Intel Technical Advisory

TA-0983-1

July 28, 2011

MiniSAS-to-SATA cable SGPIO connector incompatible with Hot Swap Backplanes FUP4X35HSBP / FR1304HSBP

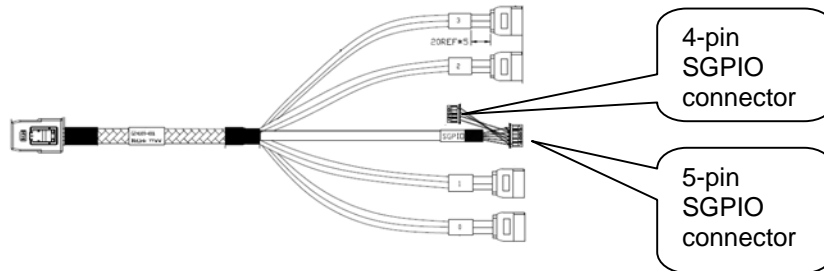
The 4-pin SGPIO connector of the E65899-001 cable cannot be plugged into the 5-pin SGPIO connector of the backplanes or systems listed above. Without the SGPIO cable connected, the listed backplane fault LED will not function with the Intel® RAID Controllers listed above.

The SGPIO connector on the backplanes or systems listed above is a 5-pin connector. The SGPIO connector on the E65899-001 cable is a 4-pin connector. The E65899-001 cable was designed before the backplanes or systems listed above were released and is not compatible with the backplanes or systems listed above.

Intel has designed a new cable (G24109-001) to support the connection between the affected Intel® RAID controllers and the affected backplanes or systems. This cable will have both a 4-pin and a 5-pin SGPIO connectors.
